**DFCM Addendum #1**

**Reference:** USDB Storefront Window Replacement Phase 1  
DFCM Project #25262230  
U3P Event #CS25034

**Date:** February 4, 2025

# USDB Storefront Window Replacement

DFCM PROJECT #25262230  
 BUILDING ELEVATIONS  
**A201**

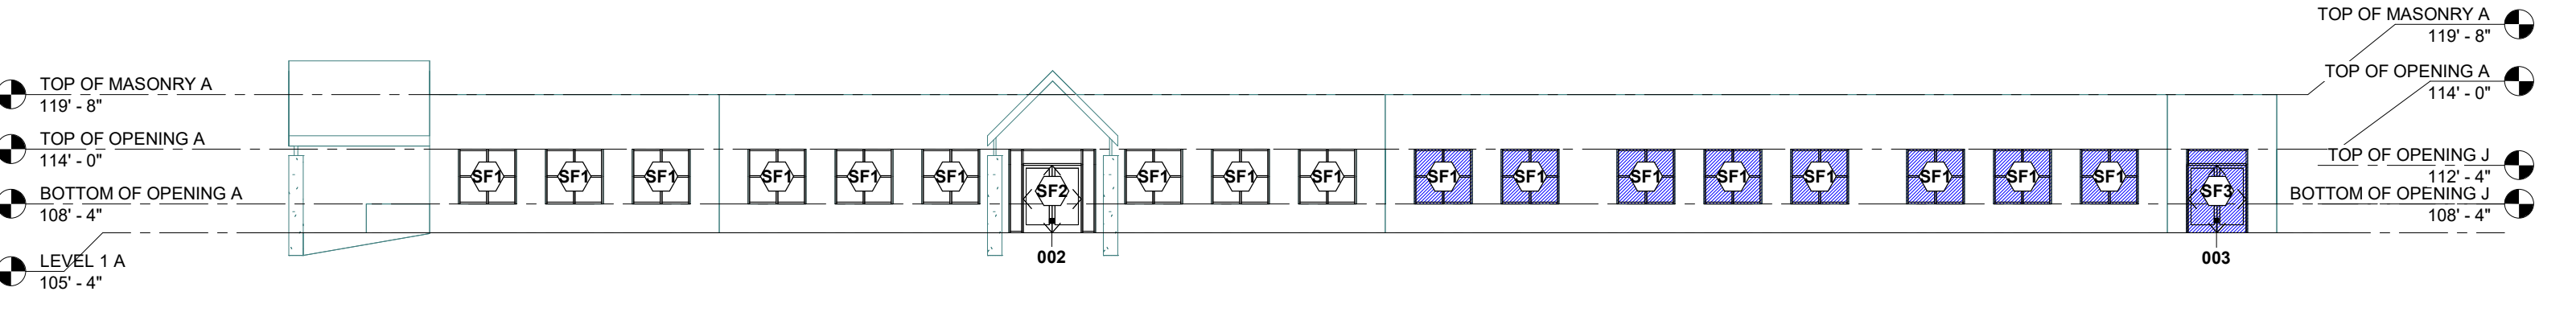
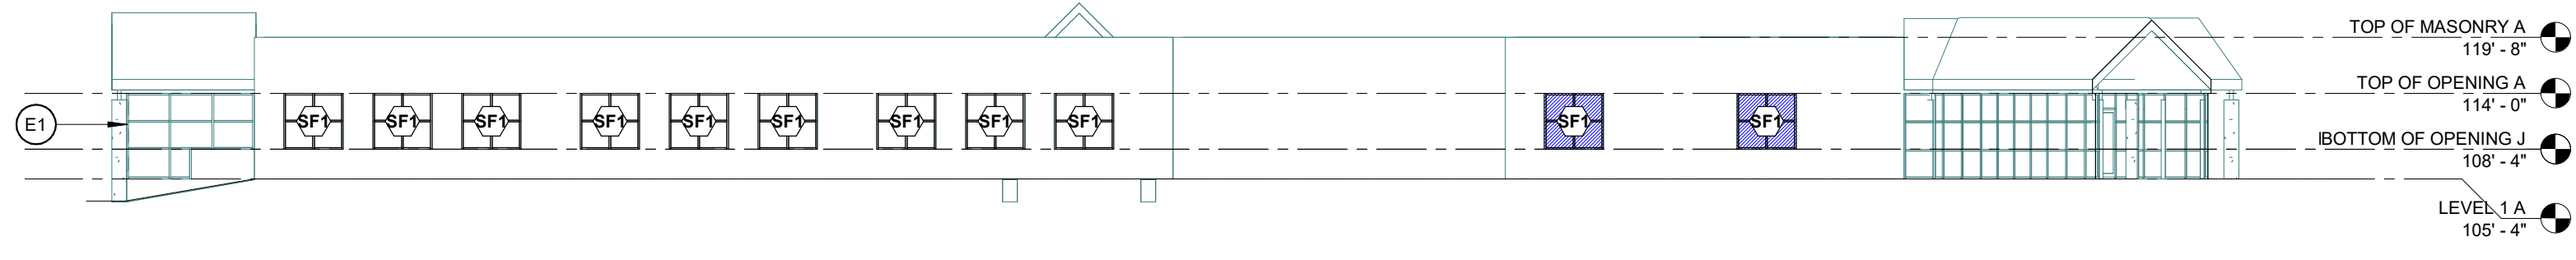
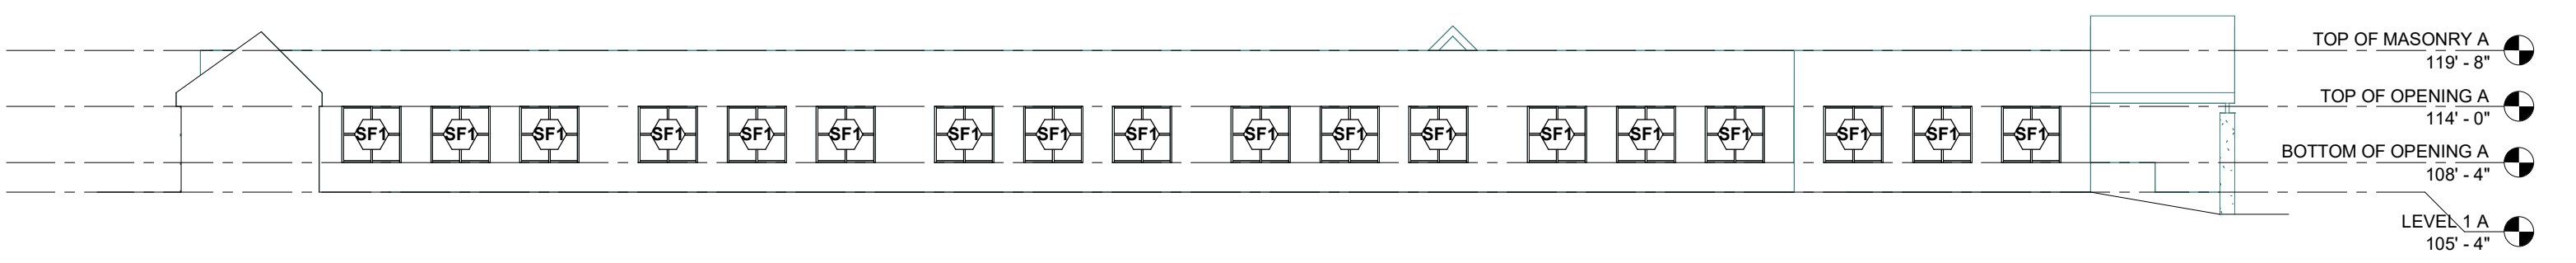
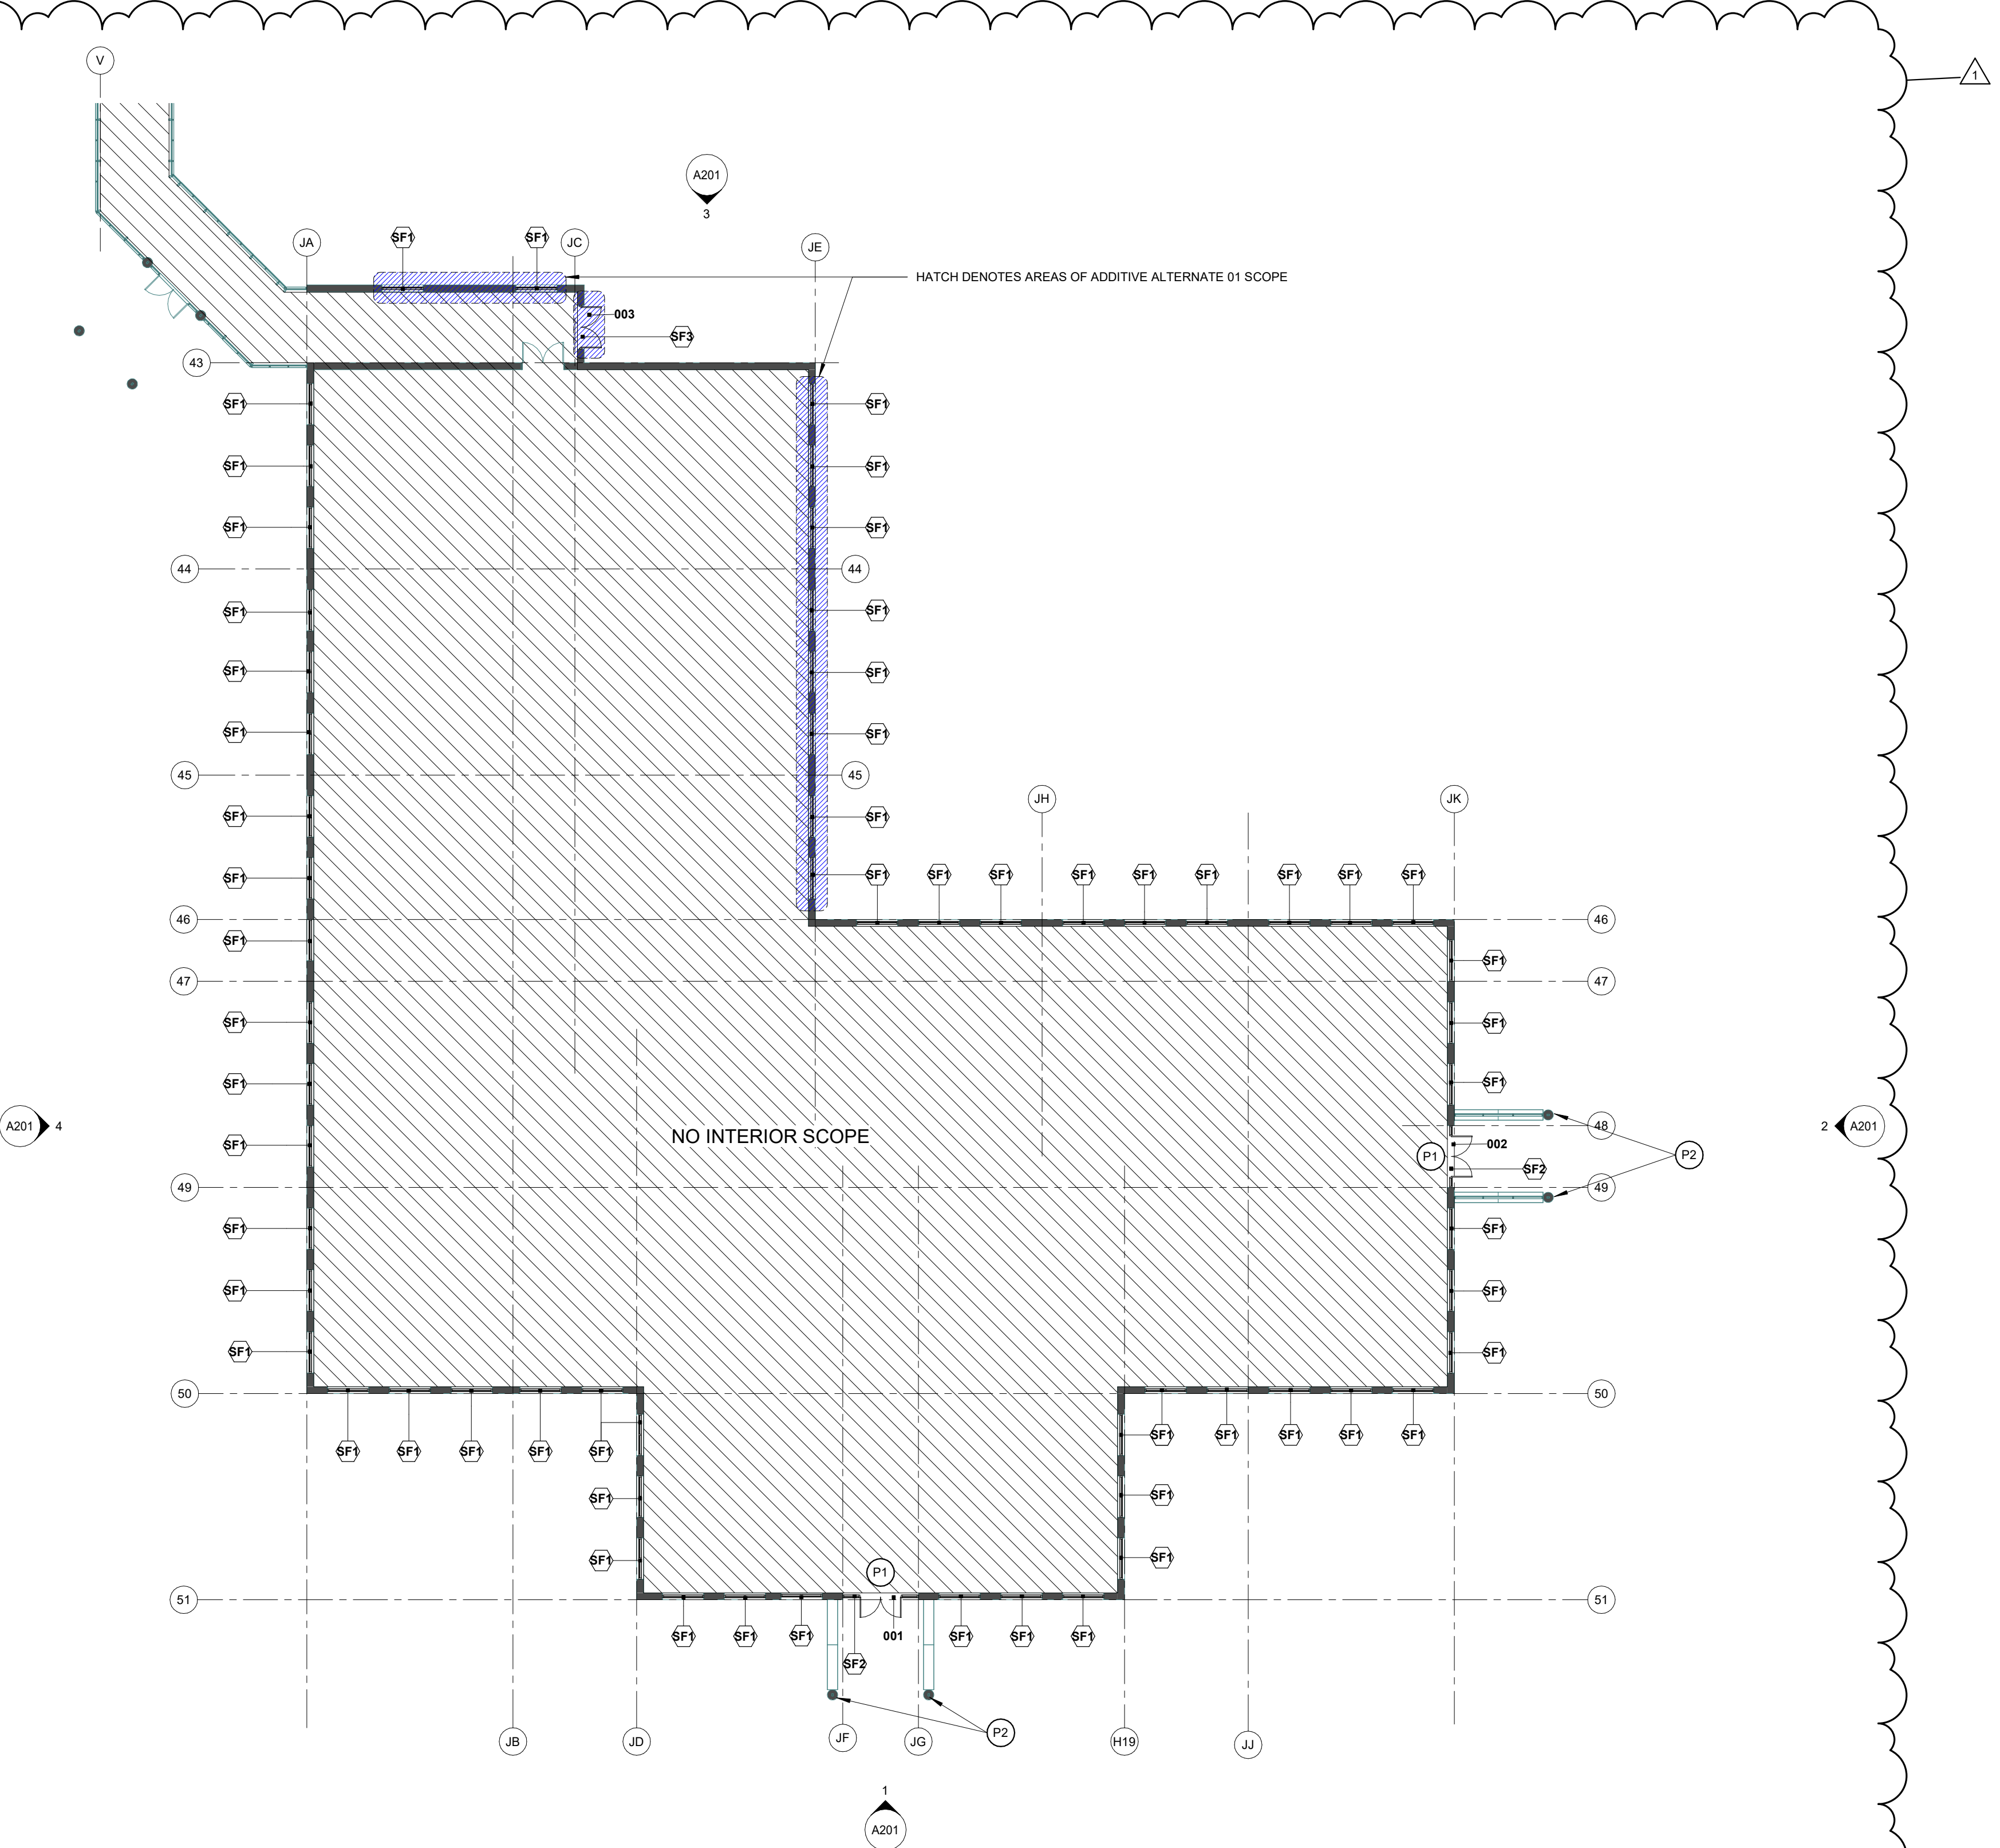
**GENERAL KEYNOTES - BUILDING ELEVATION**

- (E1) GLAZING TO REMAIN, REPLACE CAP

**ADD ALTERNATE NOTES**

ADD ALTERNATE 01 - GLAZING SHOWN IN BLUE DIAGONAL HATCH ON ELEVATIONS:

ADD ALTERNATE 02 - INTERIOR STOREFRONT DOOR REPLACEMENT:

- REPLACEMENT OF EXISTING INTERIOR VESTIBULE DOORS TO MEET ADA. SEE FLOOR PLAN FOR LOCATIONS.
- PREP NEW DOORS FOR REINSTALLATION OF EXISTING HARDWARE AND ASSOCIATED SECURITY AND ACCESS SYSTEMS. NEW PULLS MAY BE REQUIRED TO MEET CODE.

HATCH BELOW DENOTES AREAS OF ADDITIVE ALTERNATE 01 SCOPE. REVIEW EXTERNS WITH ALTERNATE NARRATIVES PRIOR TO BID.
